Application 3/2021/0275

Location: Land behind The Dog Inn, Market Place, Longridge PR3 3RR

Proposal: Proposed erection of 9 new dwellings and associated works

Proposed Site Plan
1 : 200
0 1 5 10m

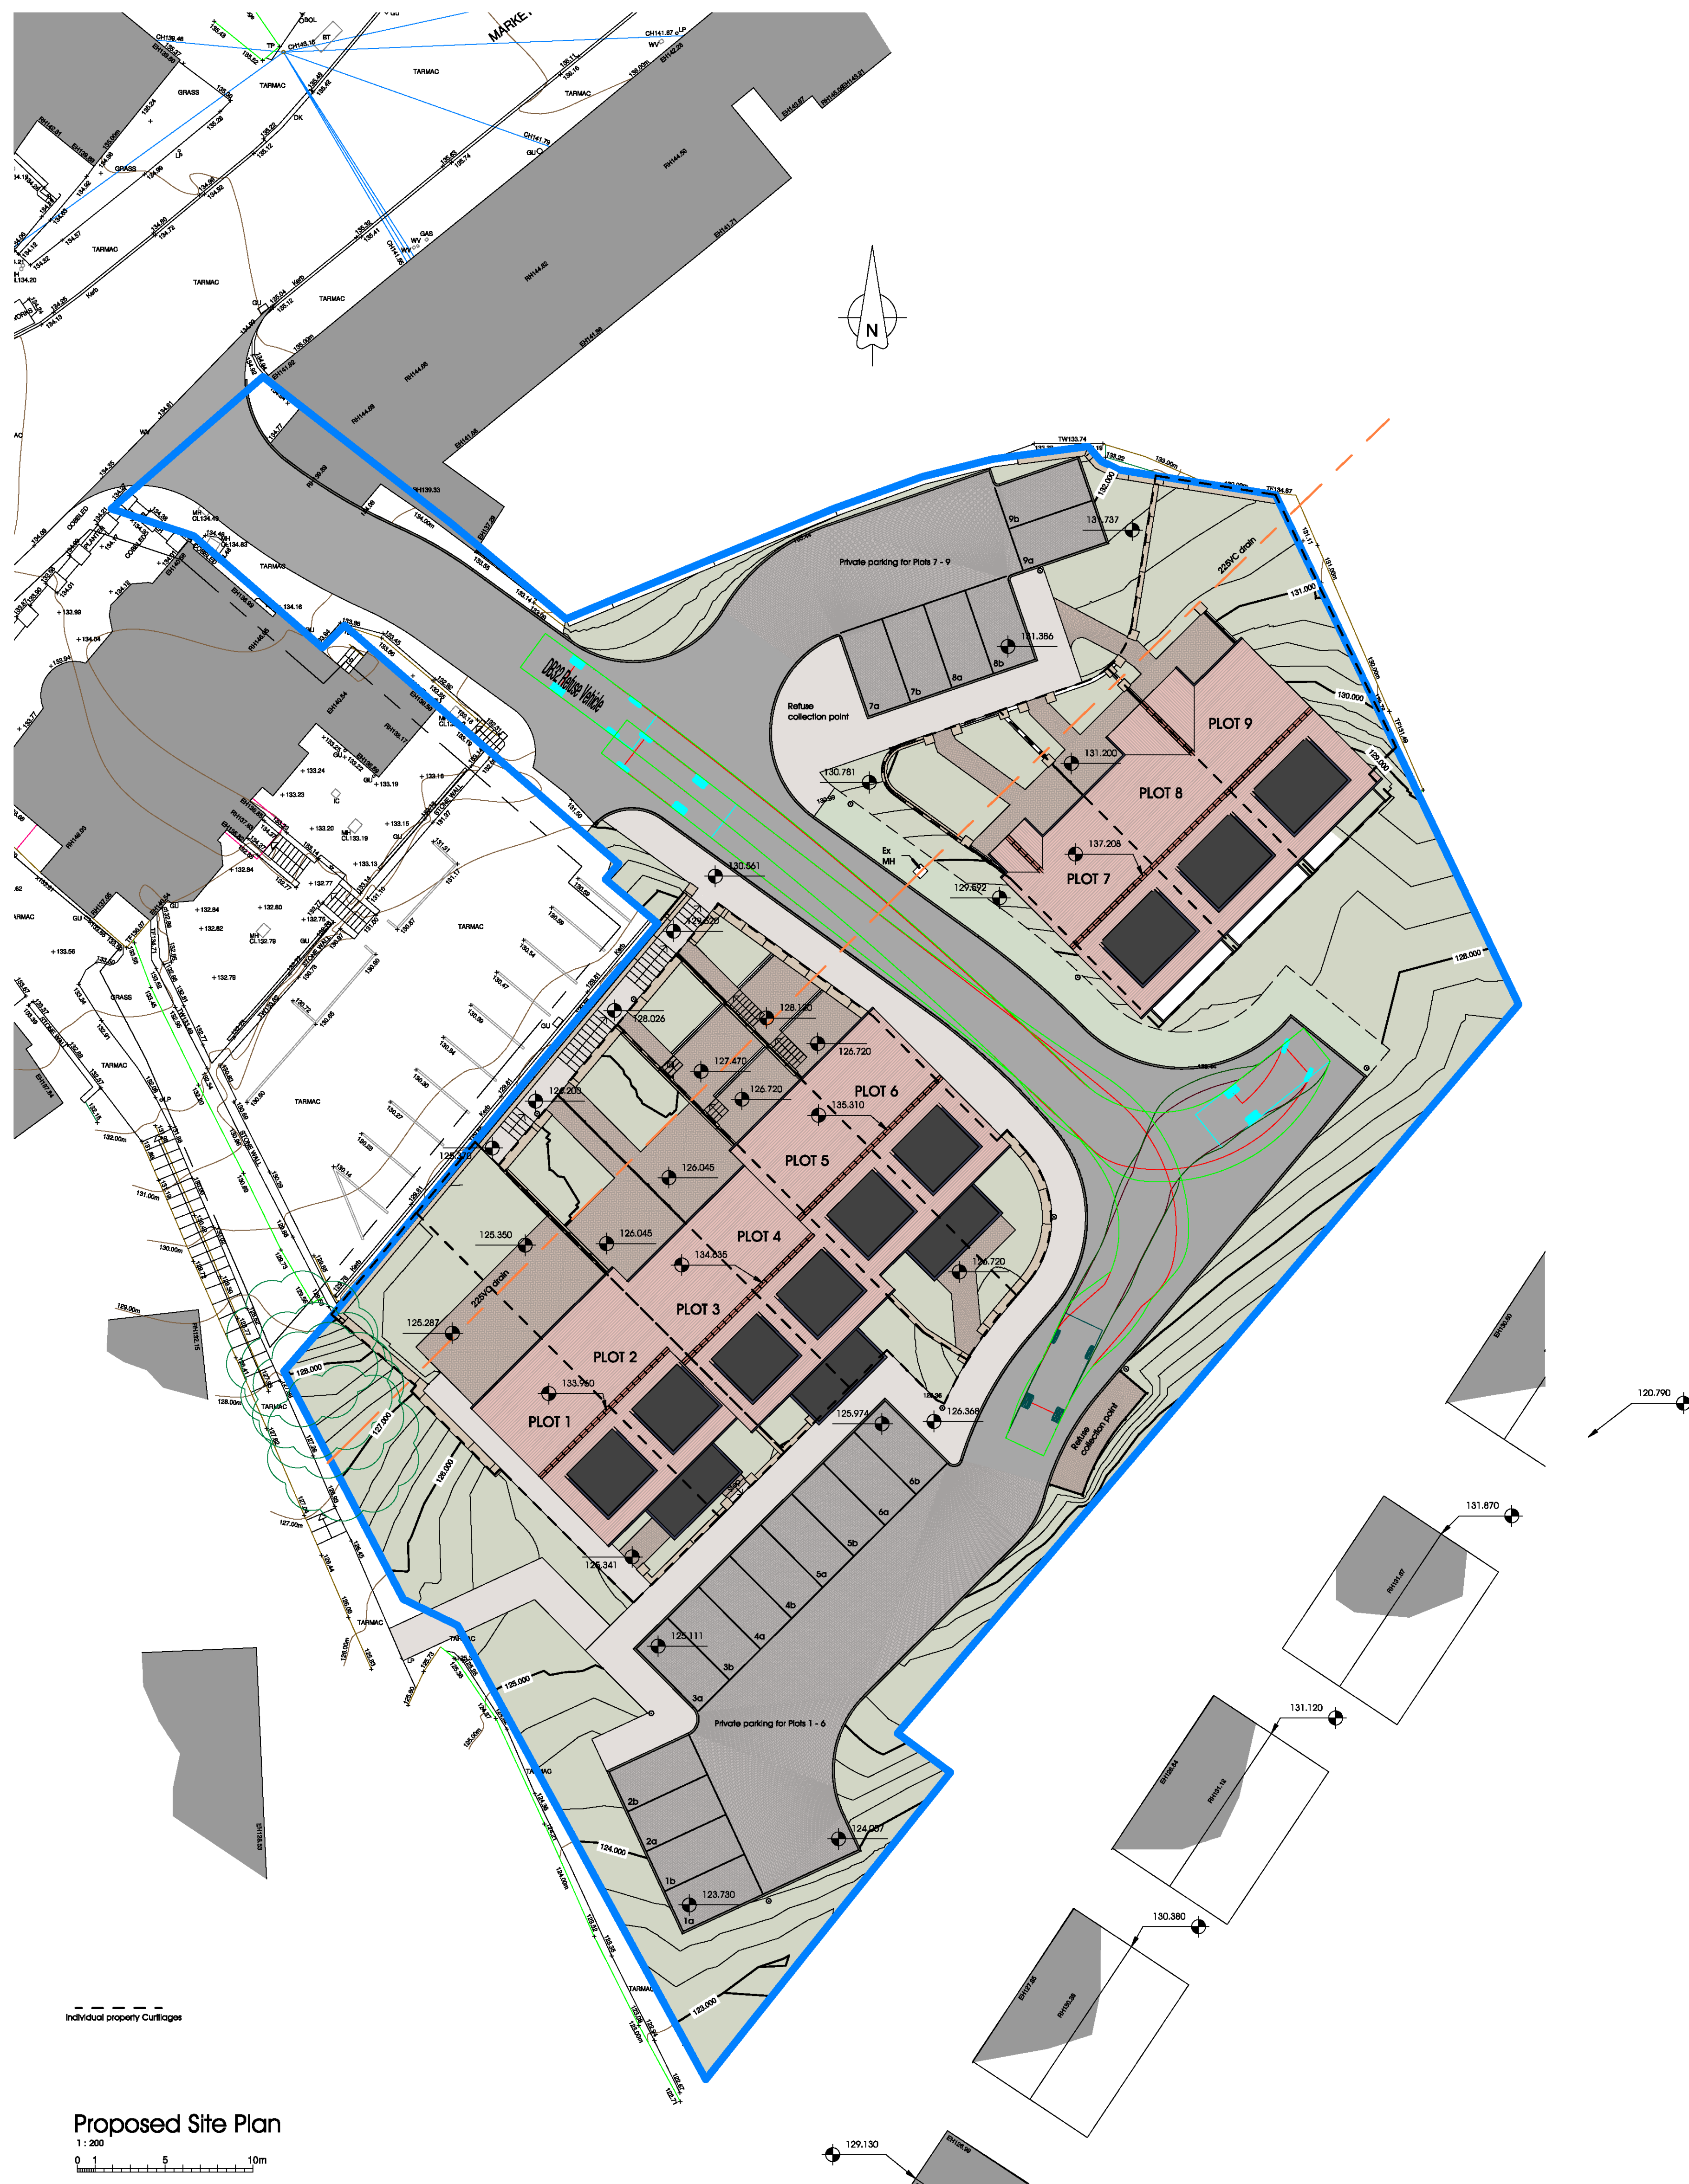
1. Proposed finished floor and ground levels for the development in metres above ordnance datum are to be confirmed. This has been requested as the topographic data suggests that some of the proposed properties will be at a lower level than the manhole cover level on the 225mm public sewer that passes through the site. For low-lying sites (where the ground level of the site is below the ground level at the point where the drainage connects to the public sewer) care should be taken to ensure that the properties are not at increased risk of sewer surcharge.

2. Additional information to understand the change in ground levels and the proposed stepped access in the context of United Utilities sewer as access to the public sewer will need to be afforded for maintenance, repair and replacement. It is unclear from the plans if the required access strip of 6m (3m either side of the sewer, measured from the centre line) is being met.

Response: The finished floor and ground levels are shown on the attached plans in relation to the public sewer that crosses the site.

It is intended that the foul water from the developed site will be discharged into the public sewer by installing a new manhole on the sewer just before it leaves the development site at its southern most point, which is also the lowest point of the site. The manhole cover of this new manhole will be below the proposed finished floor levels of the dwellings and as such the dwellings will not be at risk of flooding should surcharging of the sewer occurs.

Response: The attached plans also provide information with regards the change of ground levels and the proposed stepped access in the context of United Utilities sewer. The site plan that was submitted in support of the planning application, and is also attached, shows that a 6m easement is provided for the public sewer crossing the site. This is confirmed.
